DATE: August 4, 2017

Service Bulletin No. 632B
(Supersedes Service Bulletin No. 632A)
Engineering Aspects are
FAA Approved

SUBJECT: Identification of Connecting Rods with Non-Conforming Small End Bushings

Figure 9

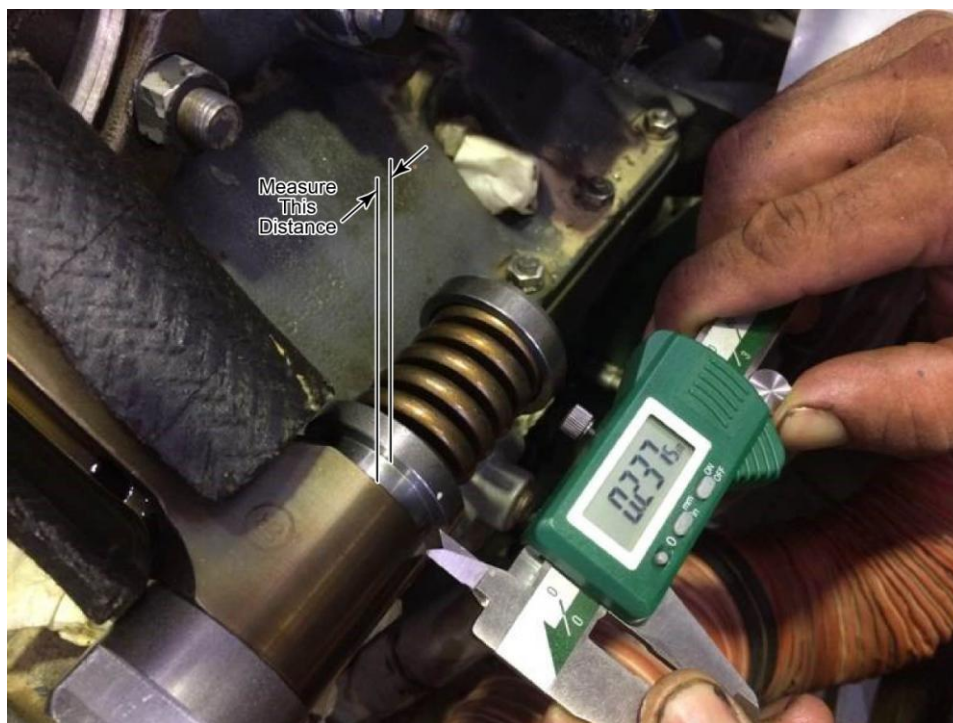
REASON FOR REVISION: Clarified MODELS AFFECTED; added NOTICE on page 1; clarified Steps 1.B and 4.B in "Required Action"; under the "Connecting Rod Bushing Press-Out Verification Procedure" - deleted Step 1 (reference to SB-630), added new Steps 7, 9, and 10 and new Figure 9 for better measuring procedure for indication of bushing movement, clarified the NOTICE after Step 11.A.(2) on page 5; added text to "use new seals and gaskets" in Steps 11.A.(4) and 11.B.(2) on pages 5 to 6; added IO-580 and AEIO-580 engine models to row for LW-12034 in the Top Overhaul Gasket Kit table on page 9

6. Use a marker to make a reference mark on the bolt head (Figure 7) to ensure an accurate count of the required number of turns during the procedure.
7. Measure the distance from the collar on the center section of the ST-531 to the edge of the connecting rod (Figure 9).

9. Re-measure the distance from the collar on the center section of the ST-531 to the edge of the connecting rod (Figure 9).
10. If the collar to connecting rod measurement has changed after turning the bolt six full turns, the connecting rod bushing has moved.
11. Turn the bolt counter-clockwise until the bottom section can be removed from the ST-531 and the tool can be removed from the connecting rod.
- A. If the connecting rod bushing has moved:
- (1) Order new parts as necessary. Refer to the “Parts Required Table” in the “Parts Required for Reassembly” section of this Service Bulletin.
 - (2) Remove the connecting rod assembly from the affected engine per the “Connecting Rod Removal” procedure in this Service Bulletin.
